PROJECT
 PUBLIC WORKS DEPARTMENT
 SECURITY AND ACCESSIBILITY UPGRADES

1155 PACIFIC AVENUE TENDER No: 139-2021
 SHEET TITLE

KEY PLAN, MECHANICAL LEGEND,
 SCHEDULES AND PARTIAL MAIN FLOOR
 PLAN - MECHANICAL DEMOLITION

SCALE	PROJECT No:	SHEET No:
AS SHOWN	2019-032	M1-R1

PARTIAL MAIN FLOOR PLAN - MECHANICAL DEMOLITION
 SCALE: 1/4" = 1'-0"

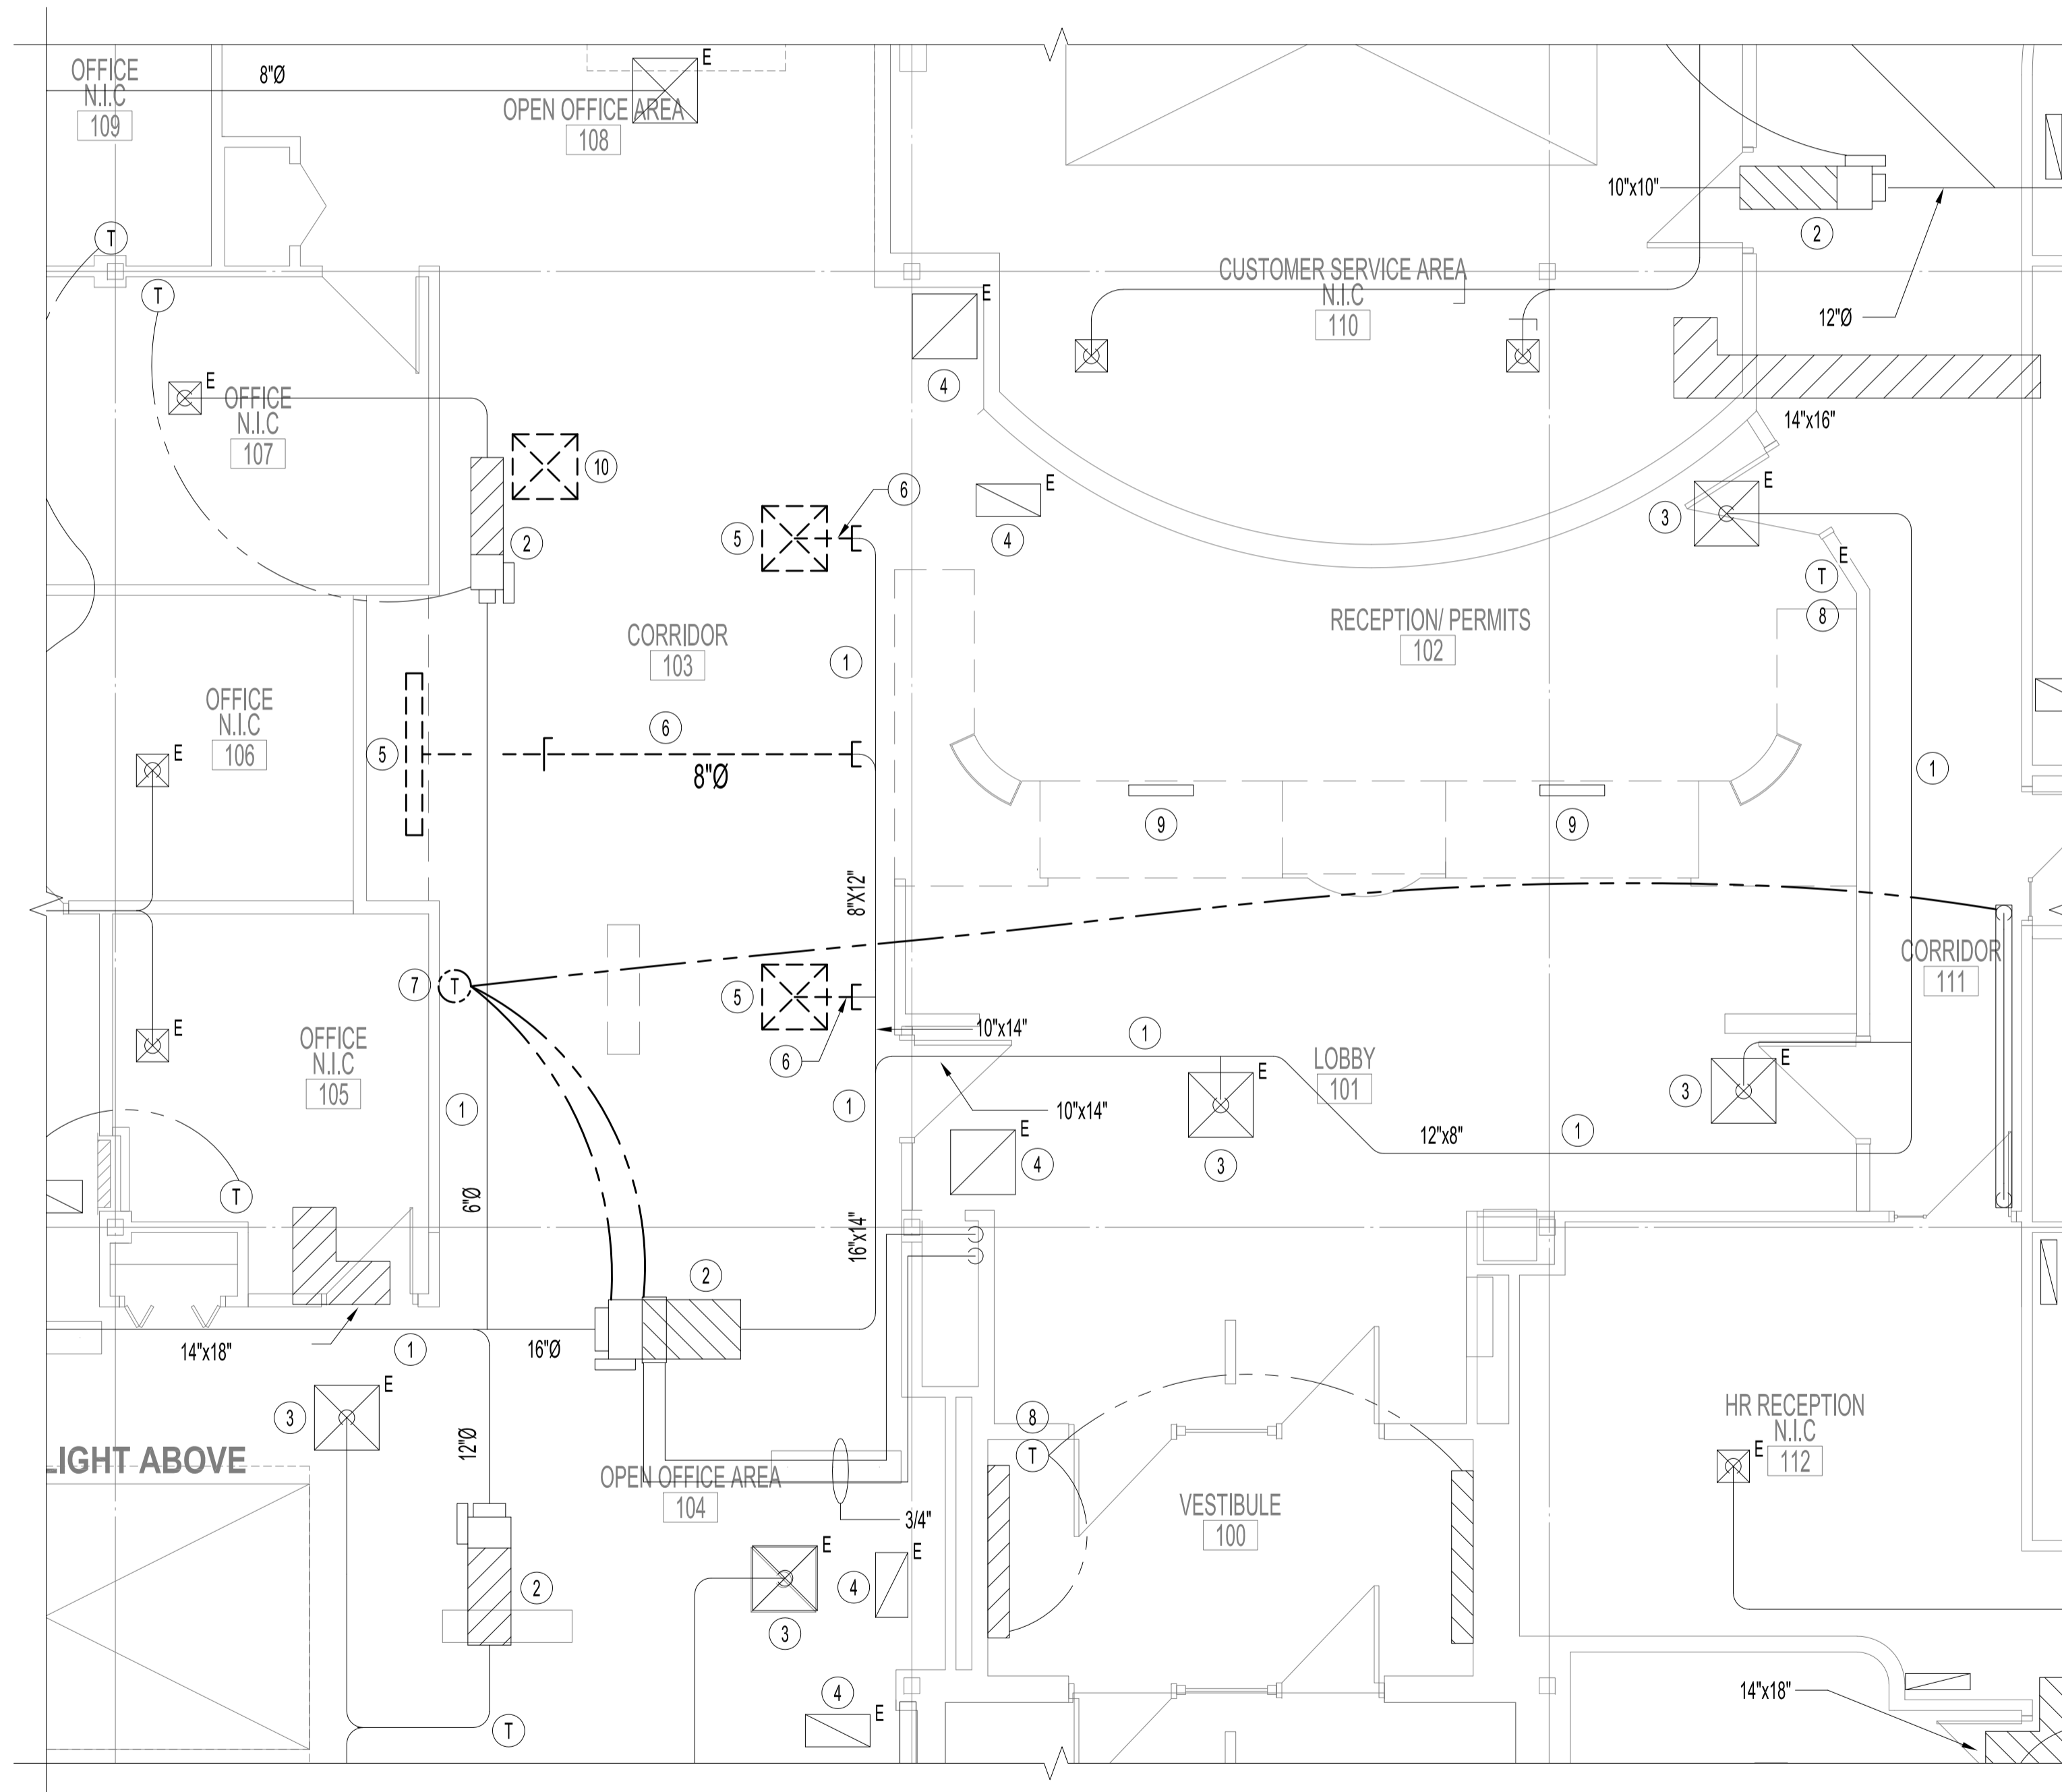
NAILOR AND TITUS PRODUCTS ARE AN APPROVED EQUAL TO SPECIFIED E.H. PRICE S-1 & R-1, IN ACCORDANCE WITH B7. SUBSTITUTES

NAILOR AND TITUS PRODUCTS ARE AN APPROVED EQUAL TO SPECIFIED E.H. PRICE TERMINAL UNITS VAV-24A & VAV-24-B, IN ACCORDANCE WITH B7. SUBSTITUTES
